Designed: 2/25/15 TIER 3 PHASE 3 M.P.177.00 TO M.P.160.00 HSR SCOPE CHANGE Rec#: WO#:22820 IS: / /NST/JVJ	Designed: 08/21/12 TIER 3 PHASE 3 M.P. 177.00 TO M.P. 160.00 UPGRADE XINGS AND CP'S FOR HIGH SPEED RAIL Rec#: WO#: 22820 IS: /MWK / /NST/MJF	CIRCUIT MODIFICATIONS ARE NOT TO BE MADE WITHOUT AUTHORITY FROM THE OFFICE OF SIGNAL DESIGN	Date: 08/21/12 Des: NST Chk: MWK AFE: 22820	UNION PACIFIC RAILROAD BROADWELL, ILLINOIS TR 149A SPRINGFIELD SUBDIVISION Office of AVP Engineering - Signal Omaha, Nebraska	Sh.: 9D DOT 294261L MP: 161.33 ID: CSL16133.9DX

UNION PACIFIC RAILROAD

BROADWELL, ILLINOIS
TR 149A
SPRINGFIELD SUBDIVISION

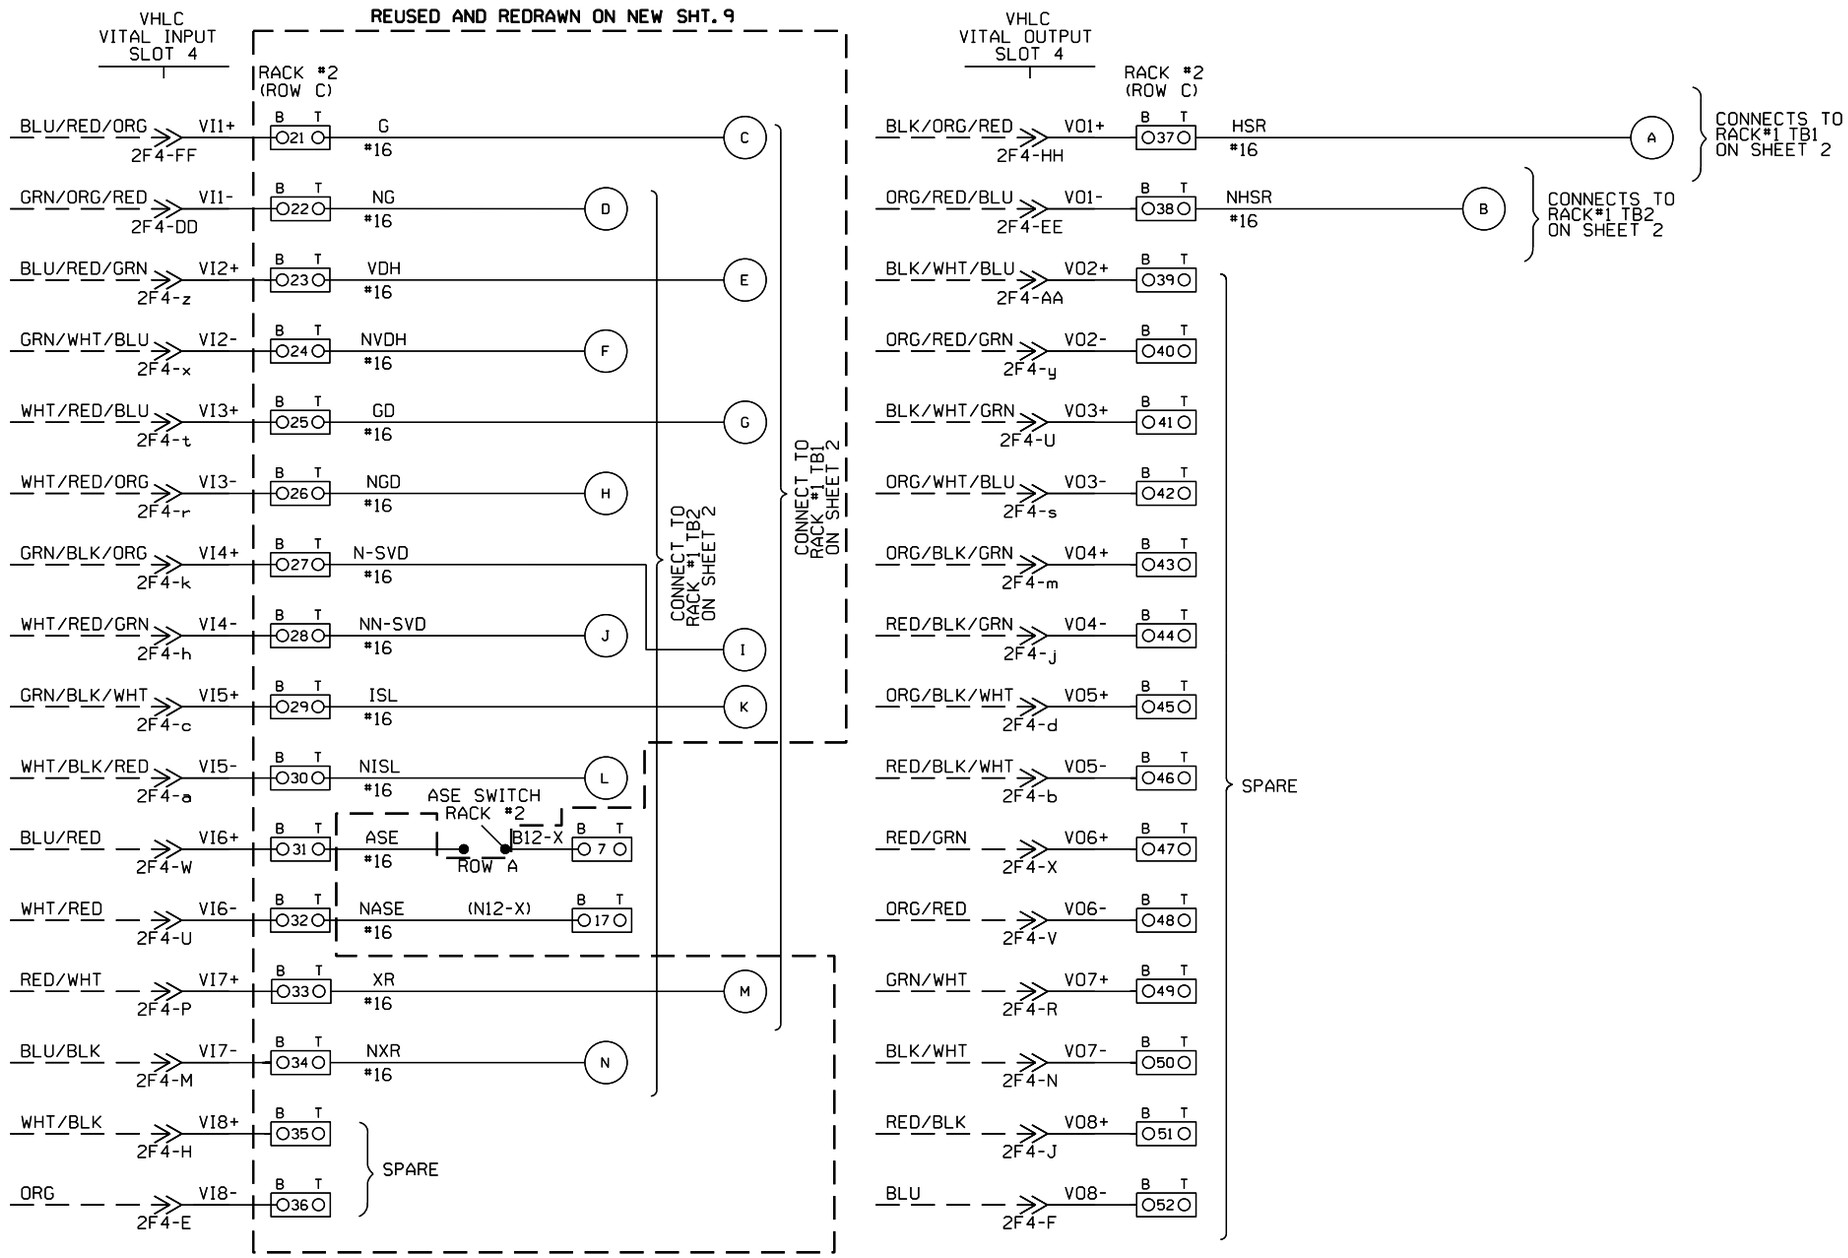
TO BE VOIDED

08/21/12
W.O. 22820 NST/MJF

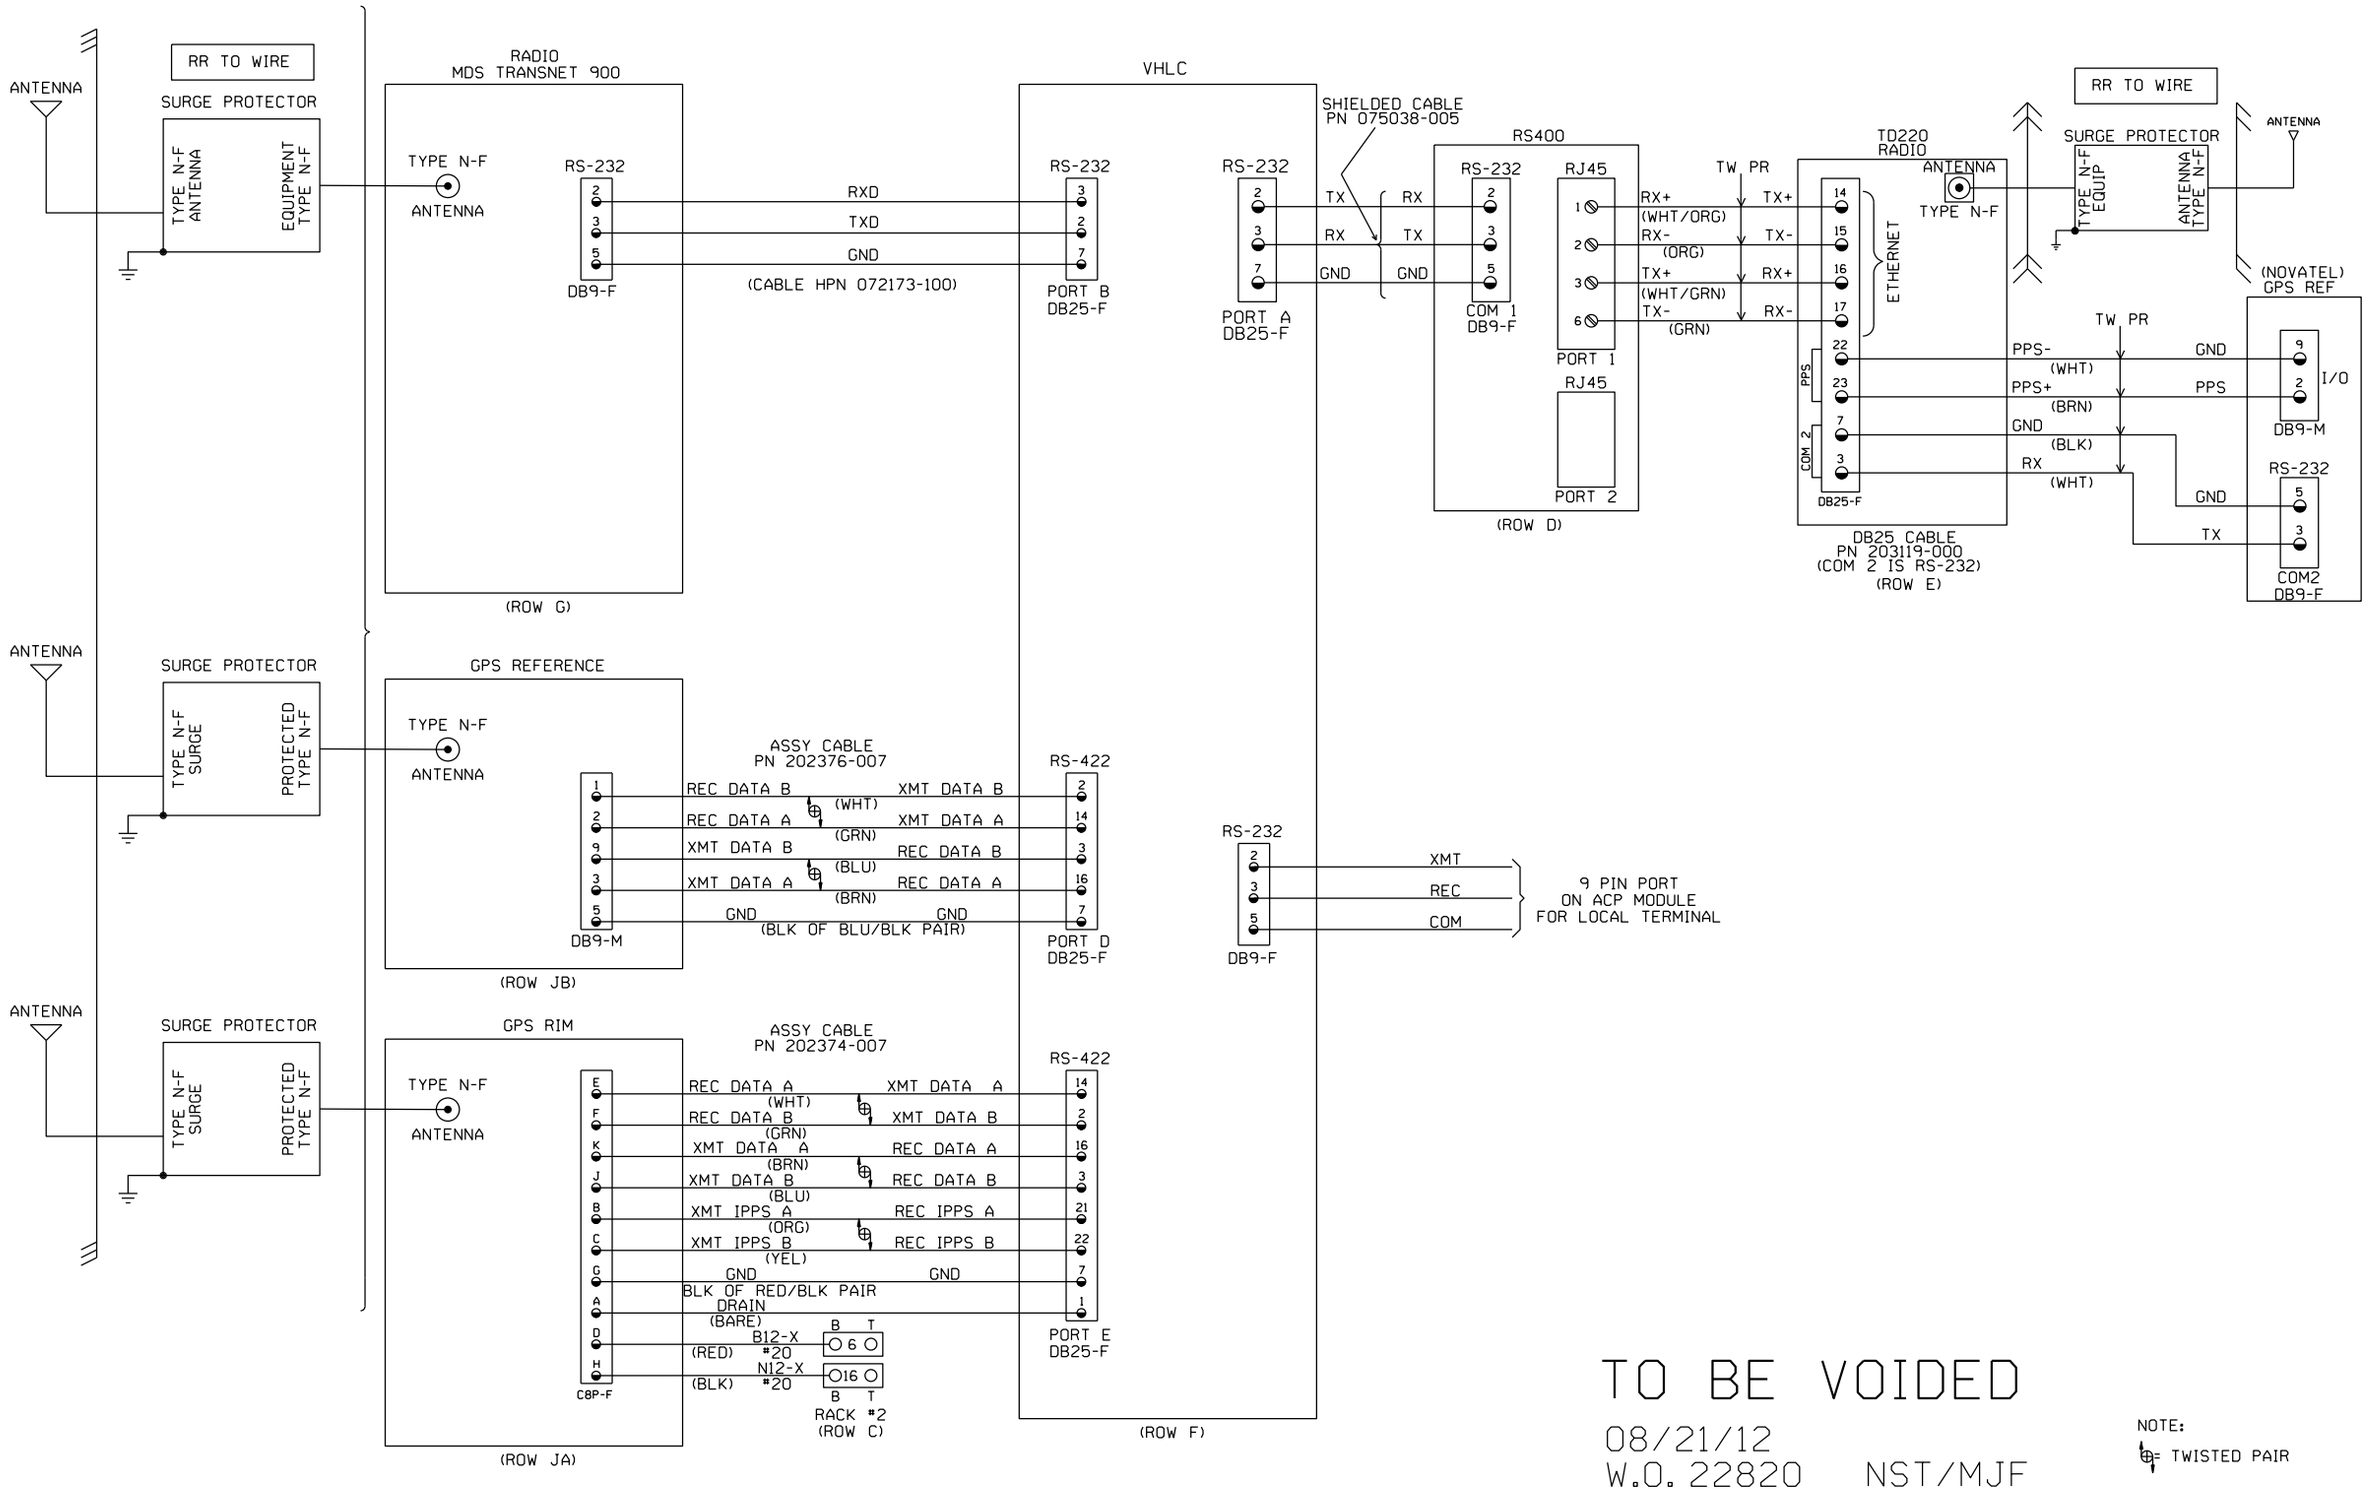
TO BE VOIDED

08/21/12
W.O. 22820 NST/MJF

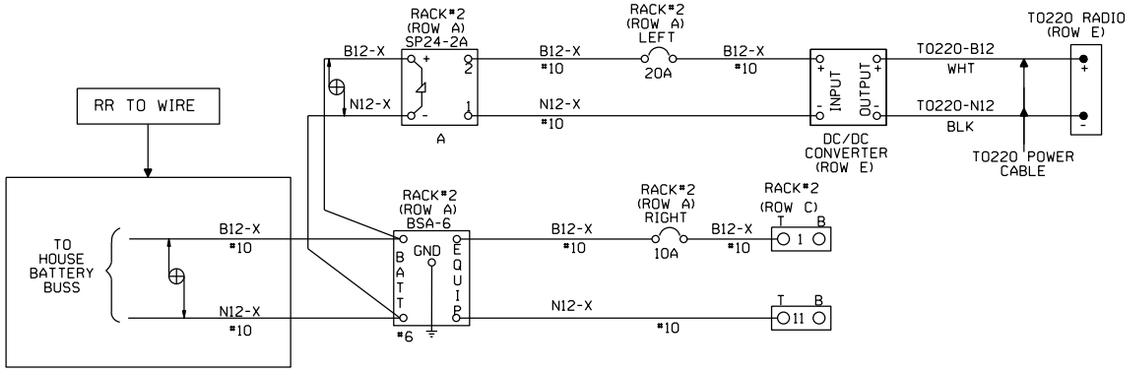
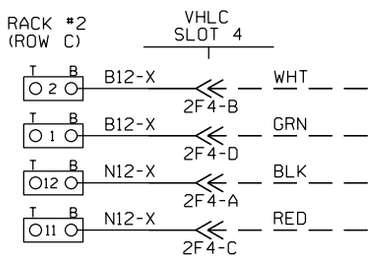
TO BE VOIDED

08/21/12
W.O. 22820 NST/MJF

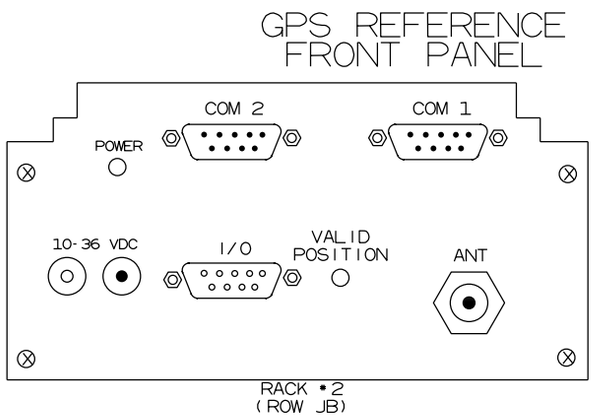
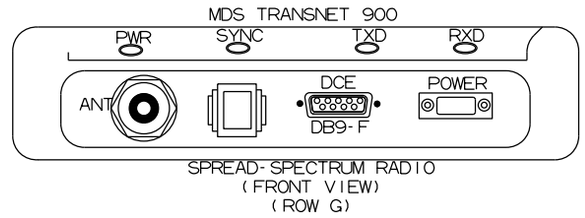
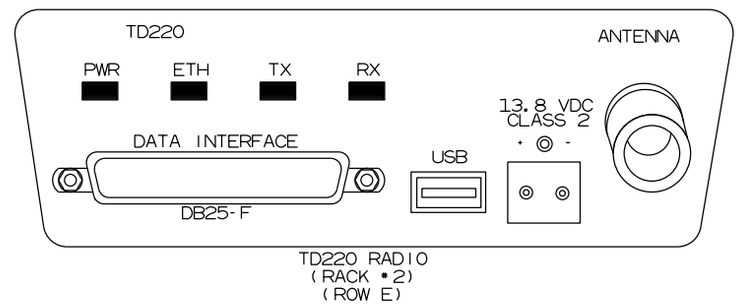
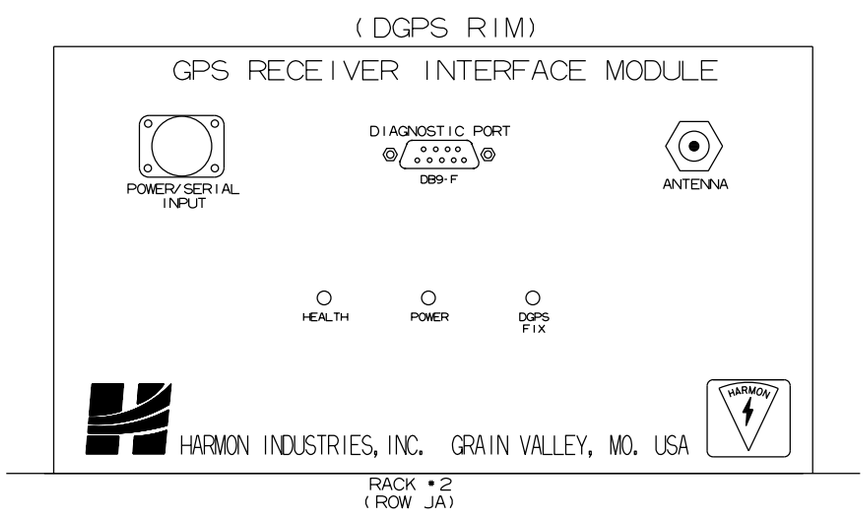
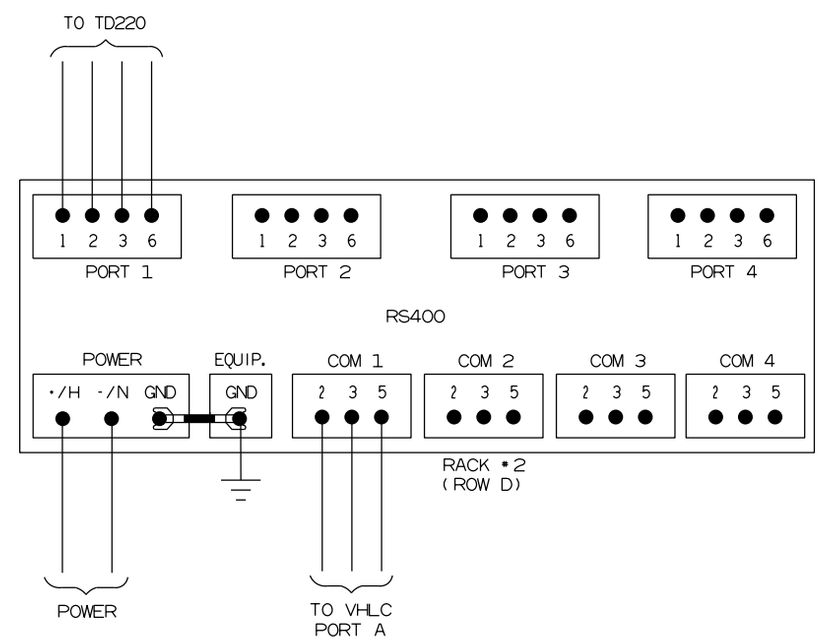
TO BE VOIDED

08/21/12
W.O. 22820 NST/MJF

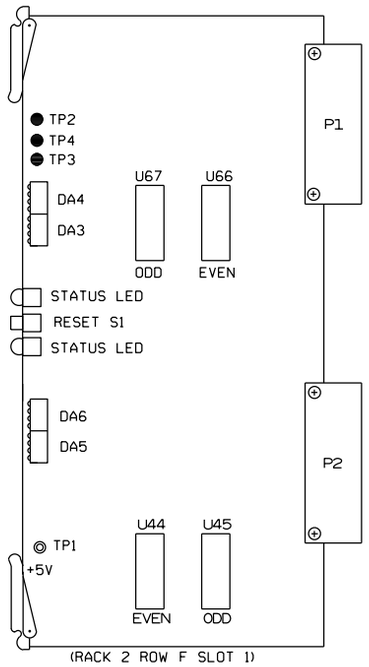
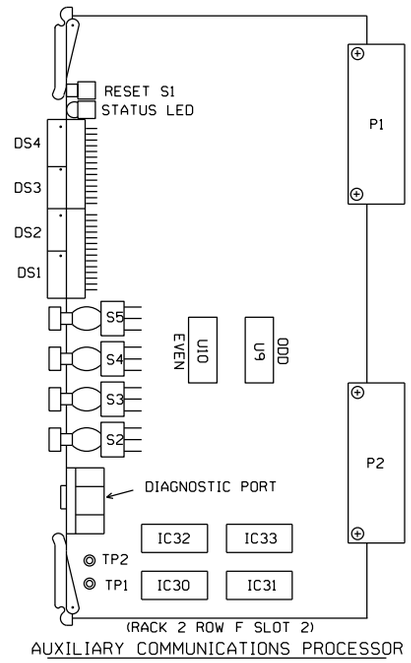
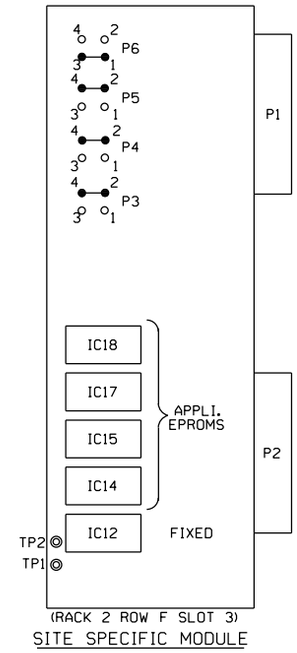
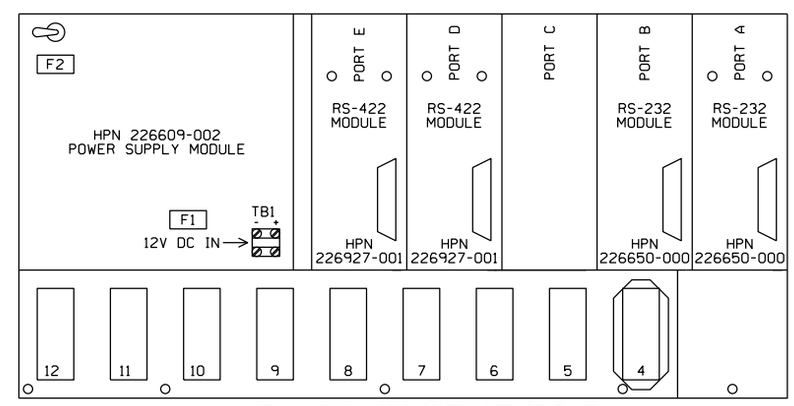
TO BE VOIDED

08/21/12
W.O. 22820 NST/MJF

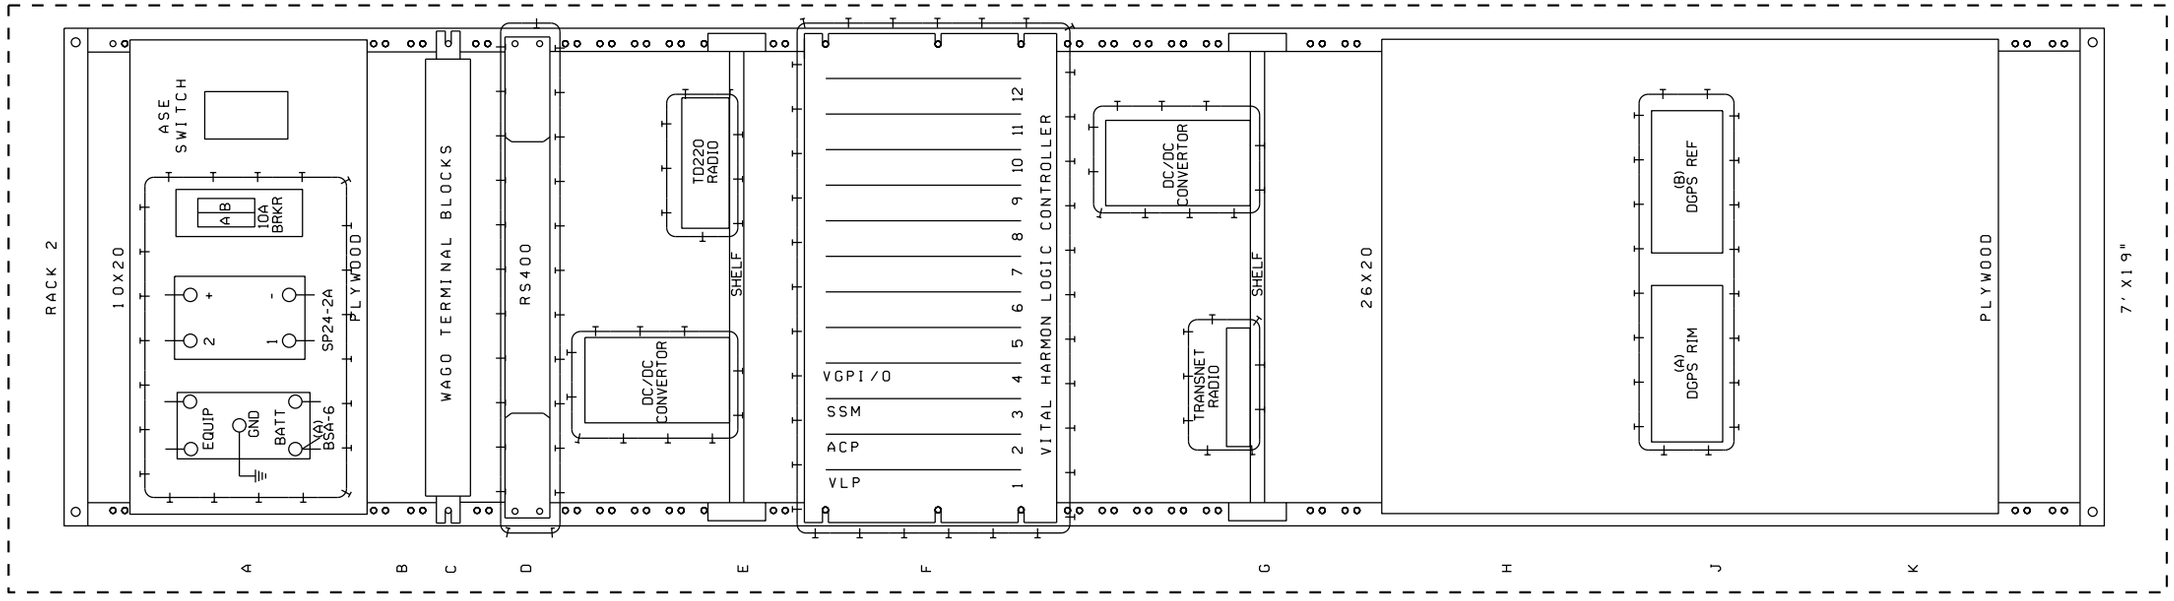
REUSED AND REDRAWN
ON NEW SHT. 9F

REUSED AND REDRAWN
ON NEW SHT. 9E

TO BE VOIDED
